Access Compliance Report

Public Rights-of-Way

(Curb Ramps)

Intersection ID: 4259	Main Street: LAKEWOOD_EDGE_DR	Cross Street: RADBOURNE_BV	Location: SE
ADA ID: BC039B6D7312	Ramp Type: Directional1	Initial Pass/Fail: Fail	Overall Compliance: No
Severity Score: 22.5			
Codes/Mitigation Info/Possible Solution		Field Measurements/Component Compliance

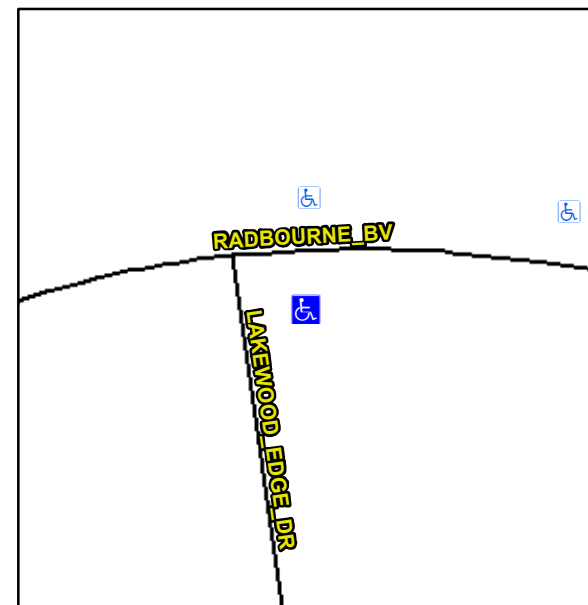
R304.5.1, R304.2.2, R304.5.3

Compliance	Description	Data	Compliance	Description	Data
N/A	Ramp Length (in)	12.0	N/A	Grade Break?	N/A
No	Ramp Width (in)	47.0	N/A	Grade Break Slope (%)	0.0
No	Ramp Slope (%)	10.2	N/A	Grade Break XSlope (%)	0.0
No	Ramp XSlope (%)	3.4			
N/A	Flare Type LT	N/A	N/A	Flare Type RT	N/A
N/A	Flare Slope LT (%)	N/A	N/A	Flare Slope RT (%)	0.0
N/A	Flare Traversable LT?	N/A	N/A	Flare Traversable RT?	N/A
N/A	Landing Length (in)	0.0	N/A	DWS Provided?	N/A
N/A	Landing Width (in)	0.0	N/A	DWS Contrast?	N/A
N/A	Landing Slope (%)	0.0	N/A	DWS Length (in)	N/A
N/A	Landing X Slope (%)	0.0	N/A	DWS Full Width?	N/A
N/A	Landing Curb? (Y/N)	N/A	N/A	DWS Offset LT (in)	N/A
N/A	Shared Landing?	N/A	N/A	DWS Offset RT (in)	N/A
N/A	Gutter Ponding?	0.0	N/A	Gutter Slope (%)	N/A
N/A	Gutter Lip Ht (in)	0.0	N/A	Gutter X Slope (%)	N/A
N/A	Painted X Walk1?	No		Road Slope (%)	2.3
	X Walk 1 Direction	To N		Road X Slope (%)	3.0
	X Walk 1 Width (in)	N/A		Clear Space?	N/A

Remove & Replace Entire Ramp.
